## **ADVANCED COMMERCIAL SUBDIVISION**

The plat illustrates the proposed 0.9 ± acre, 2 lot subdivision which is located on North side of Government Boulevard, 350'± East of Demetropolis Road, extending to the East side of Demetropolis Road, 350'± North of Government Boulevard. The subdivision is served by public water and sanitary sewer.

The purpose of this application is to subdivide a metes and bounds parcel into two lots.

# ADVANCED COMMERCIAL SUBDIVISION

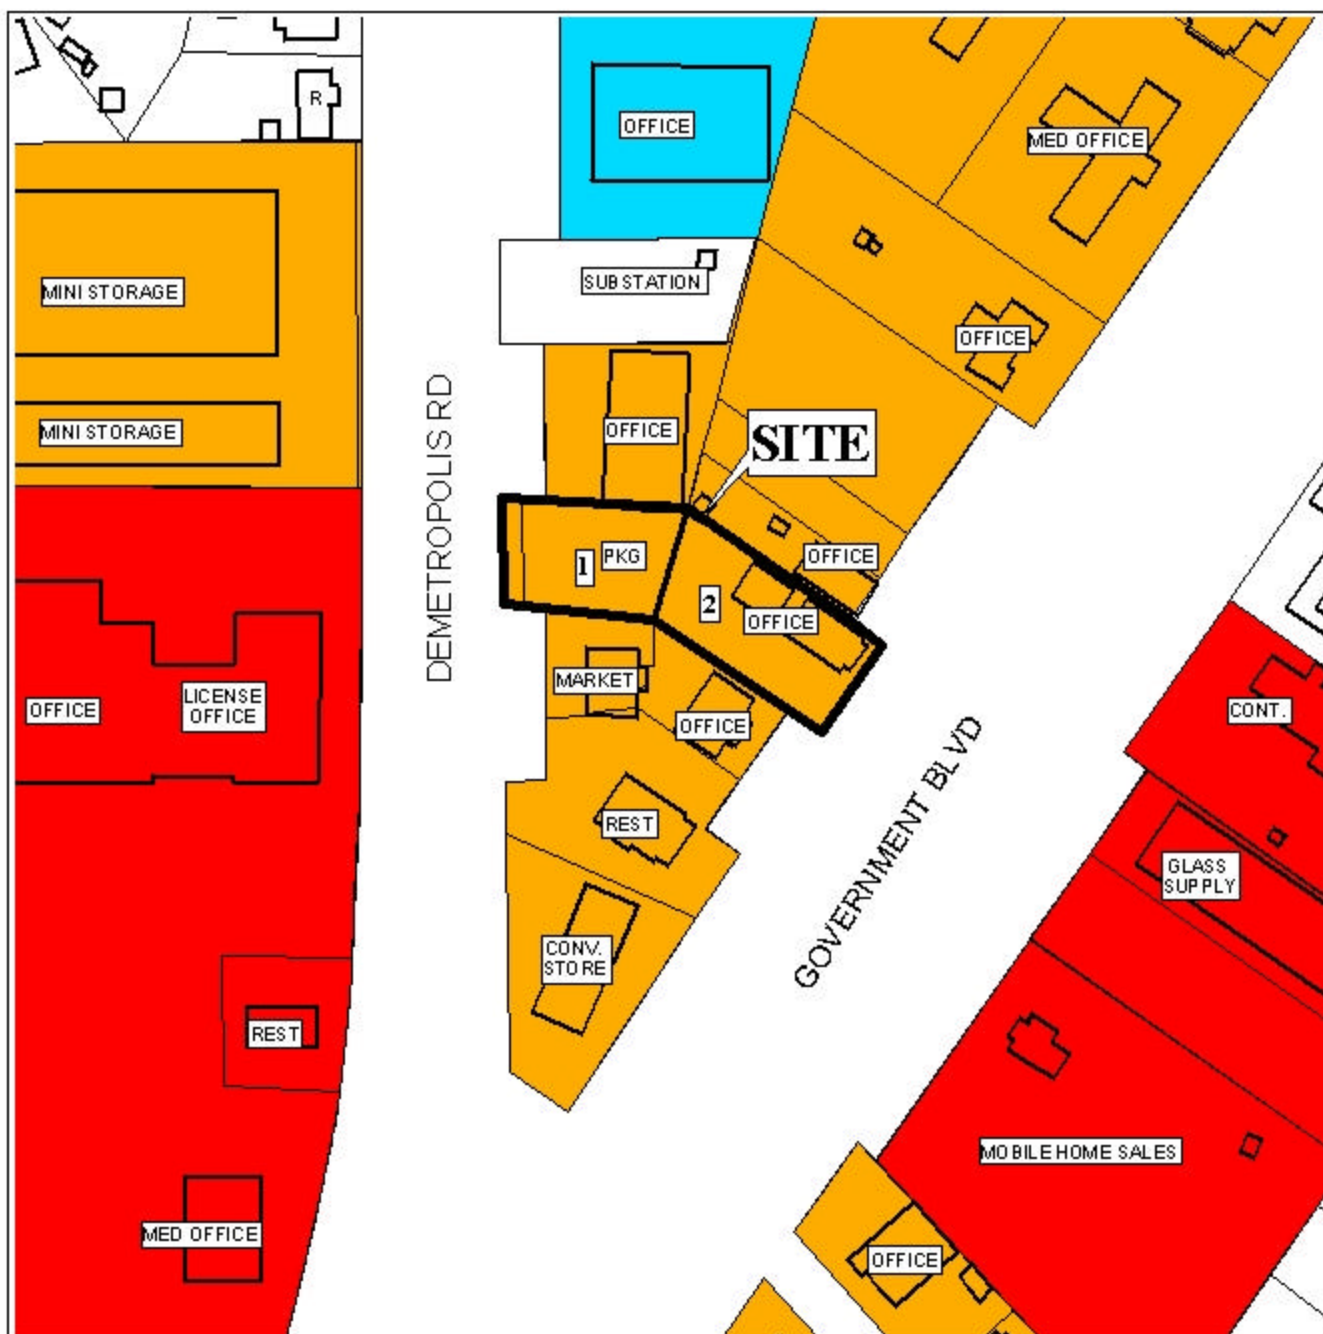
Government Boulevard, which is a planned major street, has an existing right-of-way in compliance with the Major Street Plan. Demetropolis Road, which is illustrated on the plat as having a variable right-of-way, is shown as a major street on the Major Street Plan, and as such requires a 100-foot right-of-way. Therefore, the dedication of sufficient right-of-way to provide 50-feet from the centerline should be required.

It should be noted that the site was granted a variance in 1999 to allow used car sales and a condition of that variance prohibited the car sales business on the westernmost 150' of the property. Therefore, as proposed Lot 1 could not be used for auto sales. It should be further noted that the site plan approved by the Board illustrated an asphalt drive extending from Government Boulevard to Demetropolis Road with an asphalt parking lot fronting Demetropolis Road. As illustrated on the Vicinity Map, that asphalt parking lot still exists. If the site has shared access, the submission and approval of a PUD application should be required prior to the recording of the final plat.

The twenty-five foot minimum building setback line is not shown but would be required on the final plat.

The plat meets the minimum requirements of the Subdivision Regulations and is recommended for Tentative Approval subject to the following conditions: 1) the dedication of sufficient right-of-way to provide 50' from the centerline of Demetropolis Road; 2) the submission and approval of a PUD application prior to the recording of the final plat; and 3) the placement of the twenty-five foot minimum building setback line on the final plat.
